EN0110020 – Whitestone Solar Farm

Three Joint Parishes Response

Suggested Site Inspection Locations

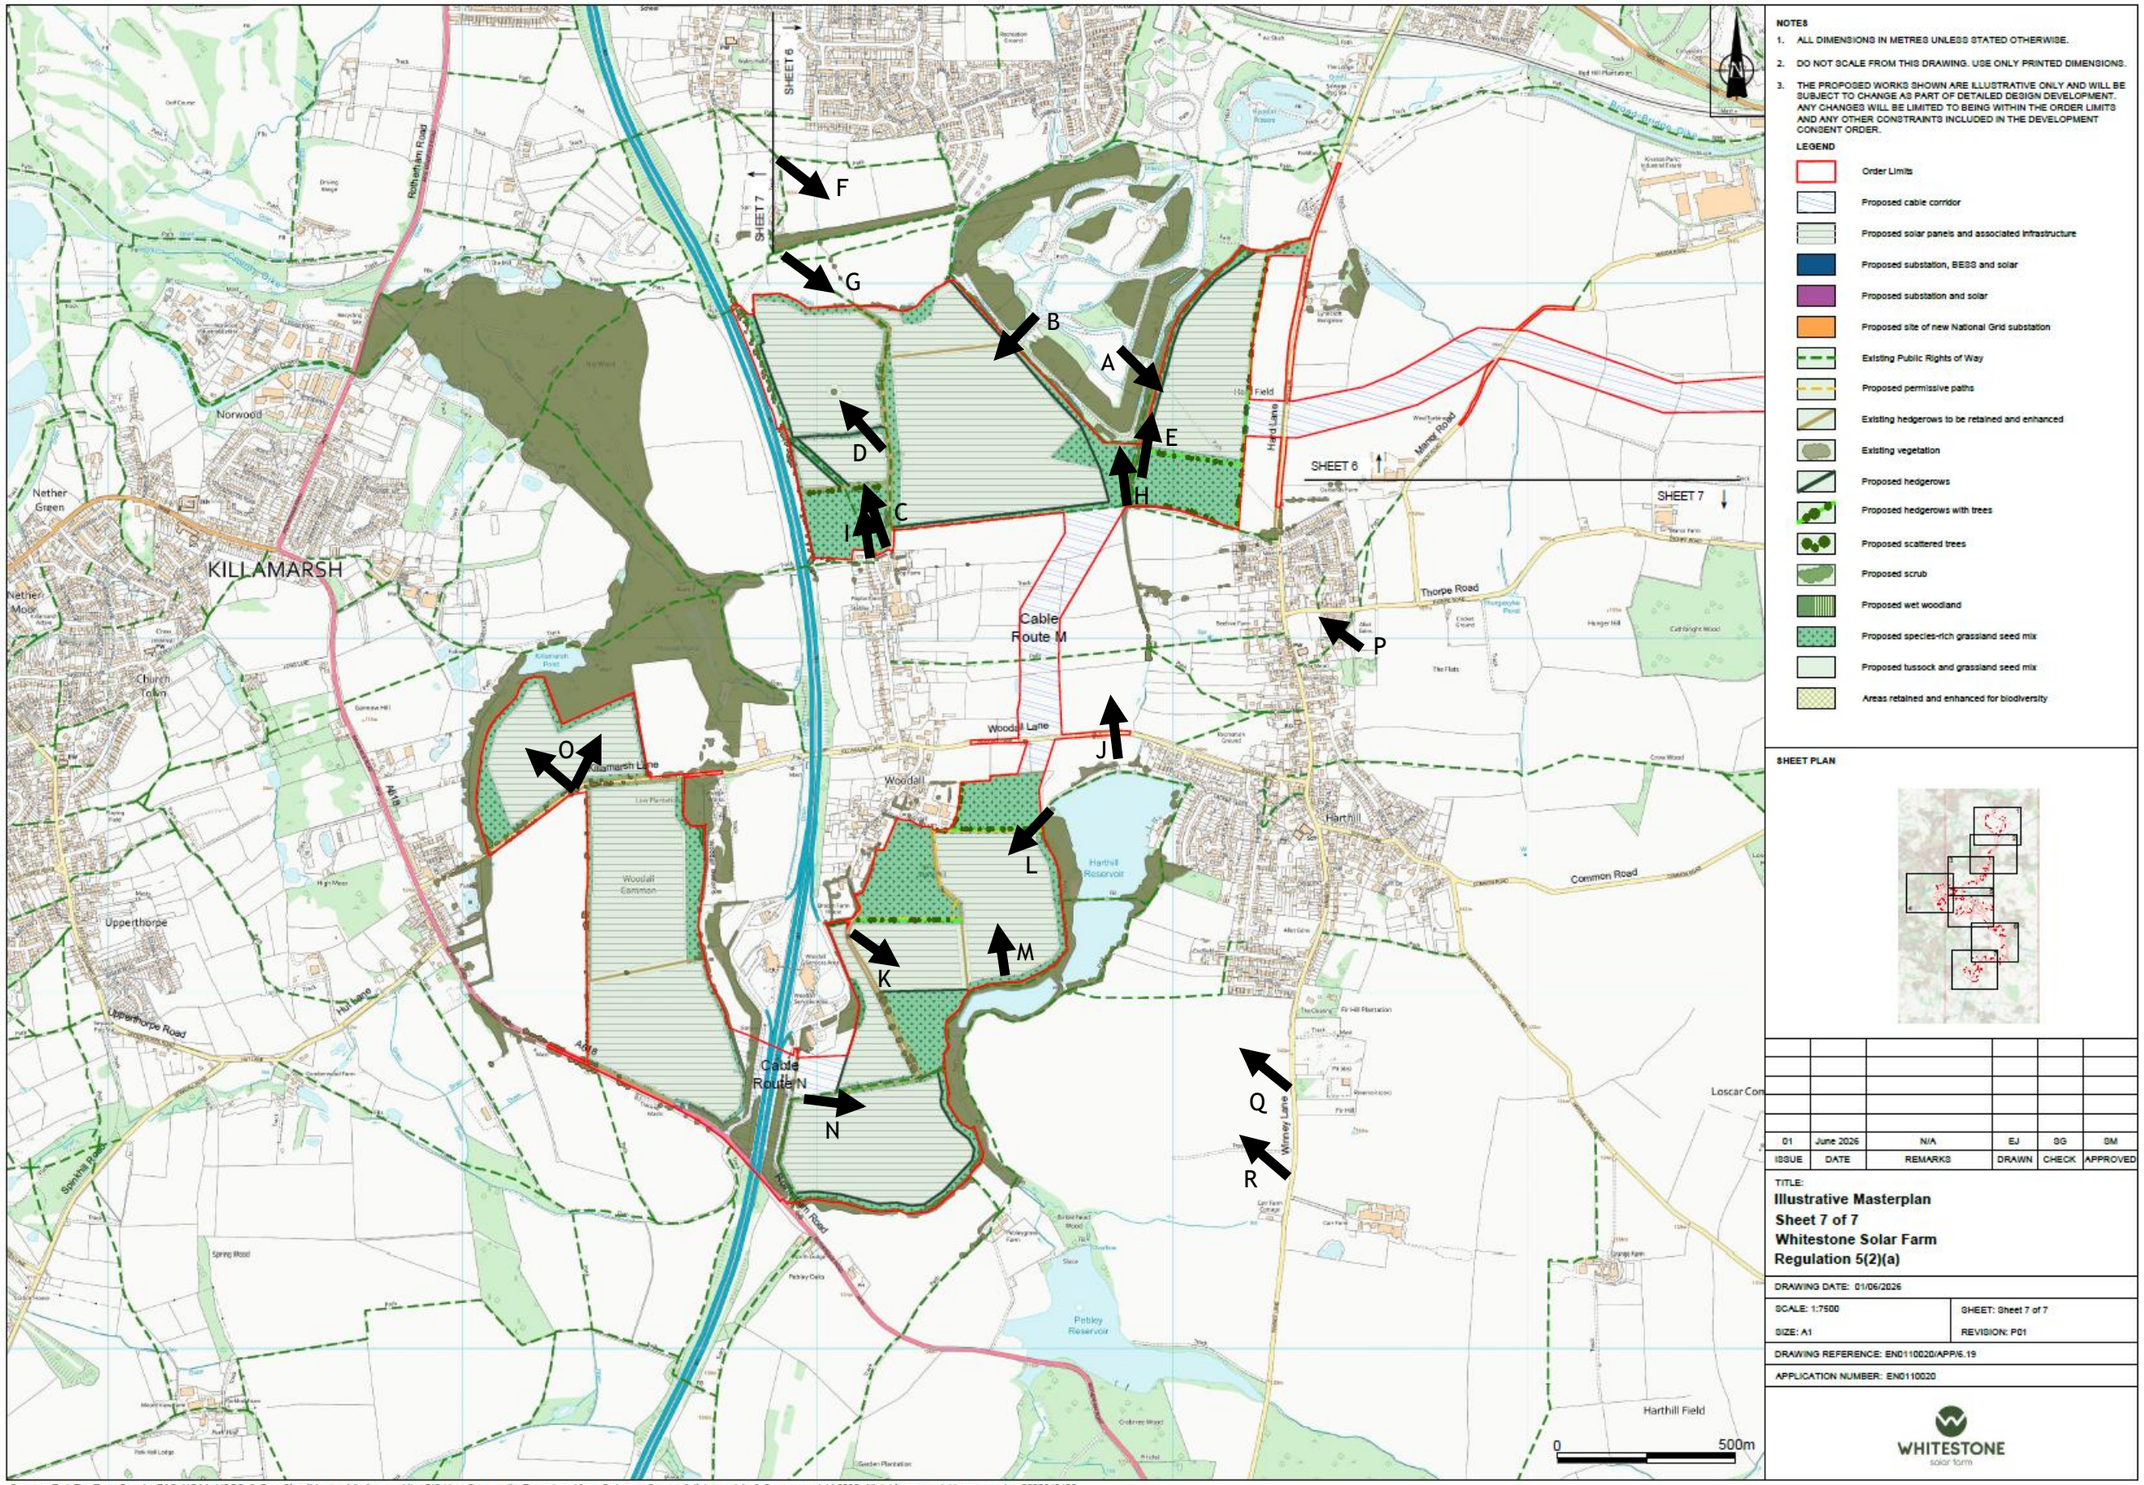
Suggested Additional Public Viewpoints (Harthill, Woodall, Kiveton Park and Wales)

Suggested Additional Public Viewpoints (South Anston and North Anston)

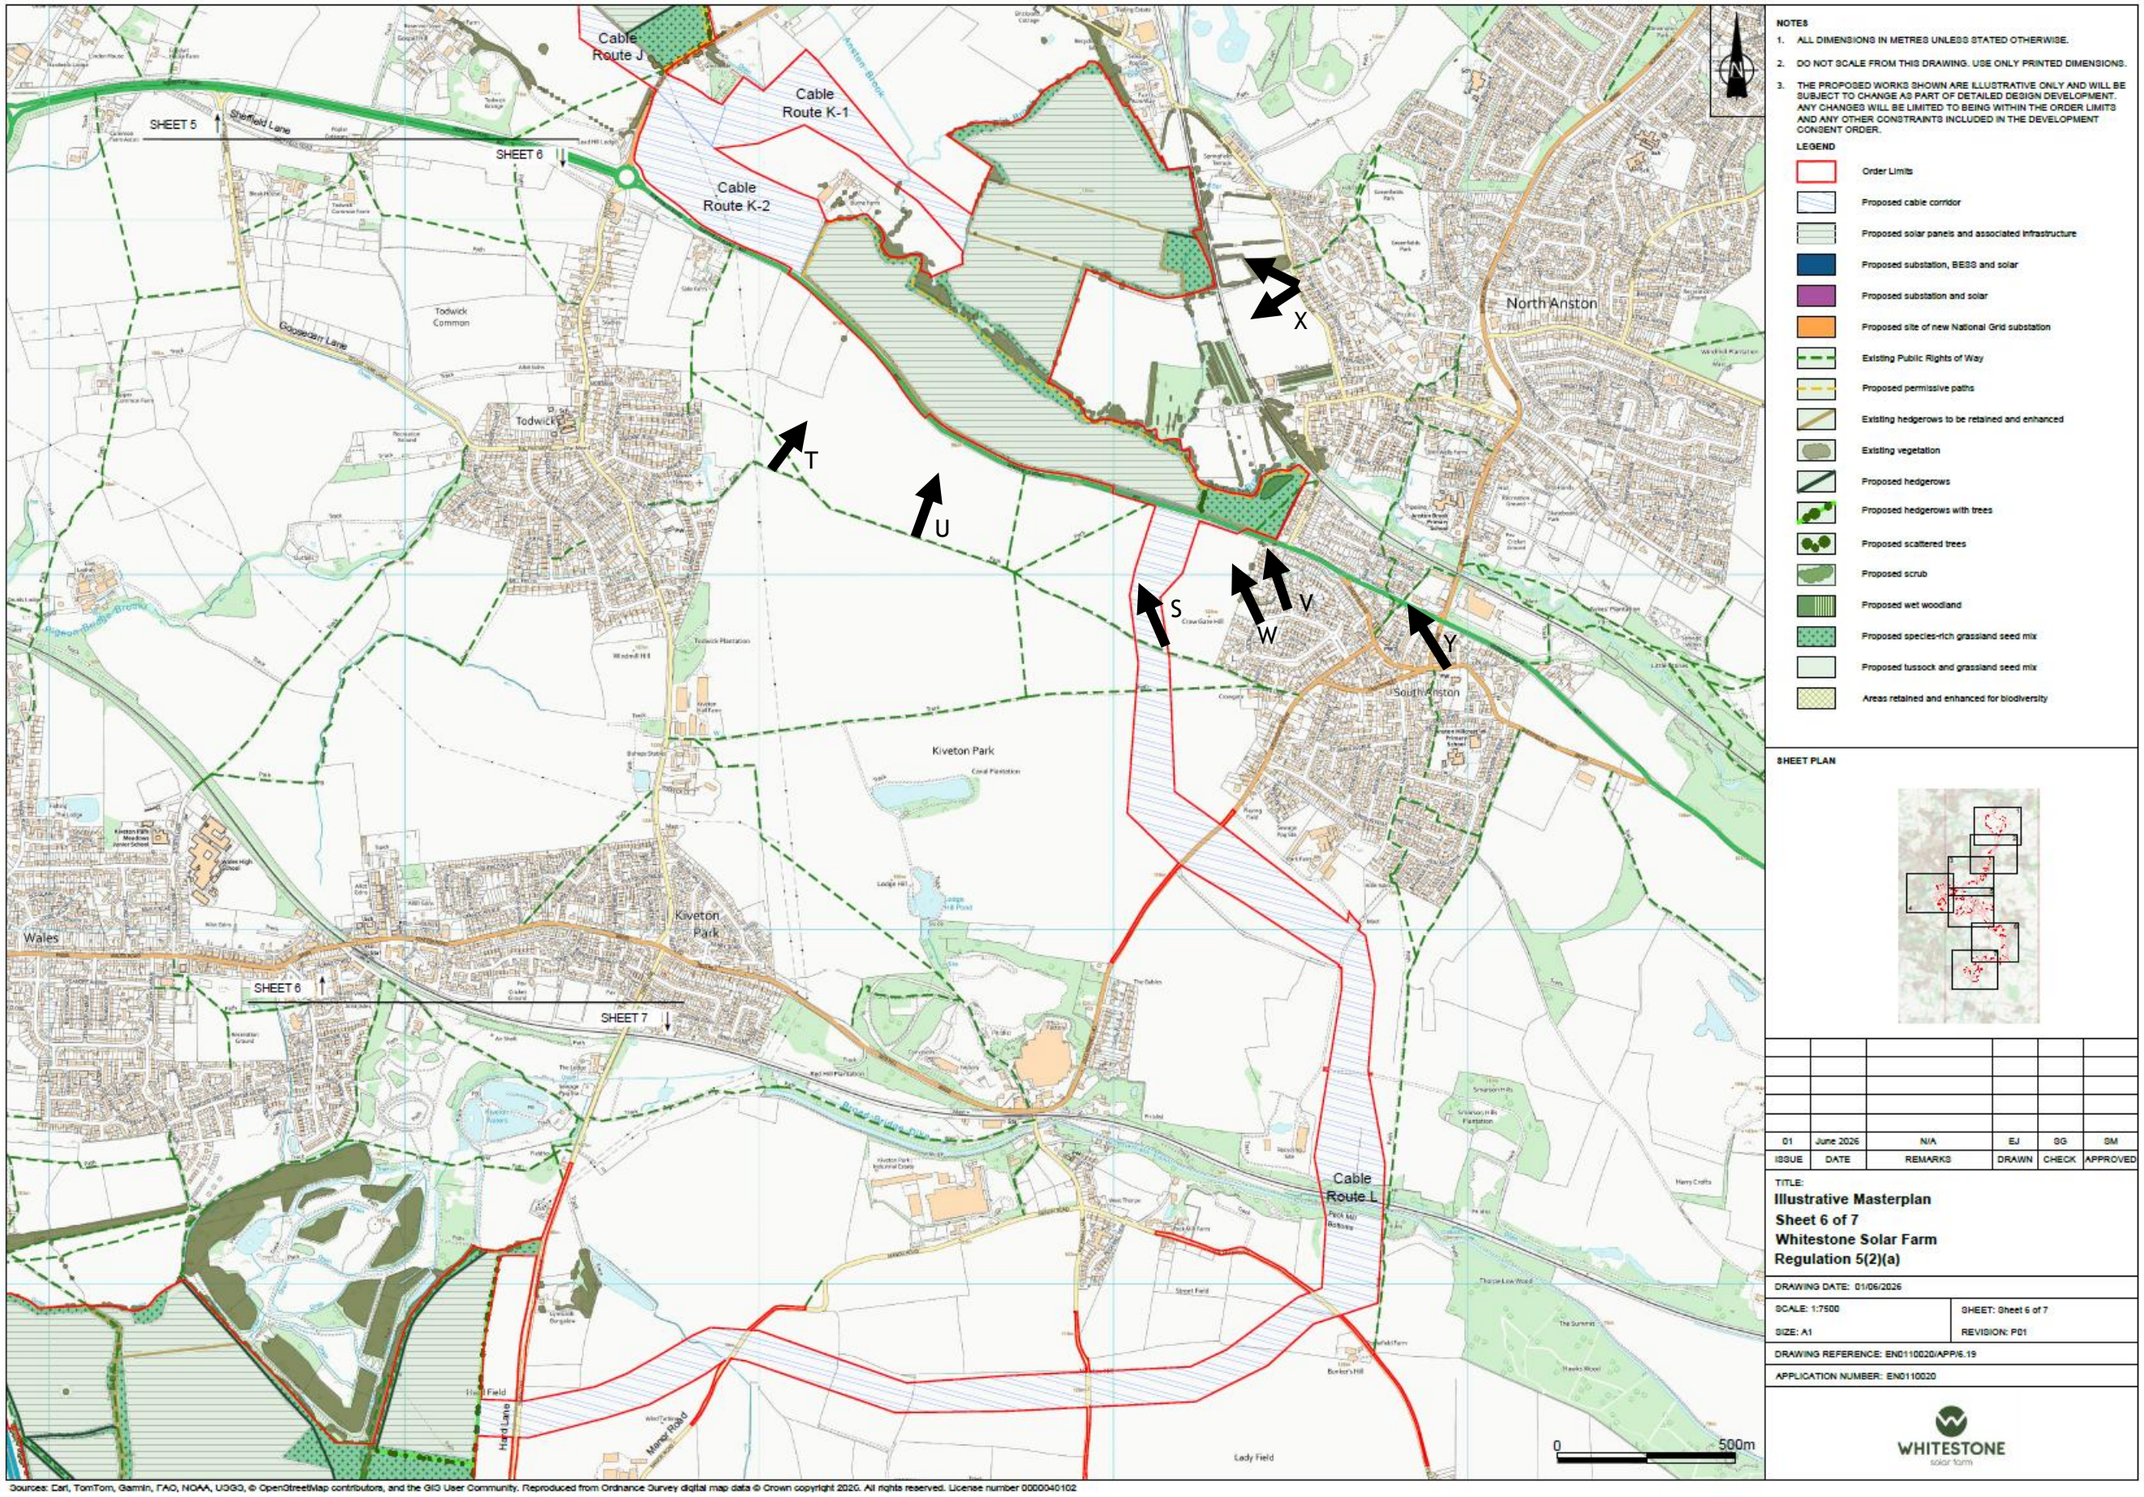
S. SK5105283839 – View from Anston Bridleway 7, looking north to north-west.

T. SK5011484268 – View from Todwick Footpath 10, looking north through to north-east.

U. SK5046983607 – View from Todwick Bridleway 12, looking north through to north-east.

V. SK 5149983891 – View from Orchard Way, looking north-west [NEW}

W. SK 51406 83872 - View from West Bank Drive, looking north-west [NEW]

X. SK 51504 84843 – View from Penny Piece Lane, looking south-east through to north-east [NEW]

Y. SK 5194283712 - View from main door of St James Church, the church is grade 1 listed and of historic interest, looking north-east [NEW]
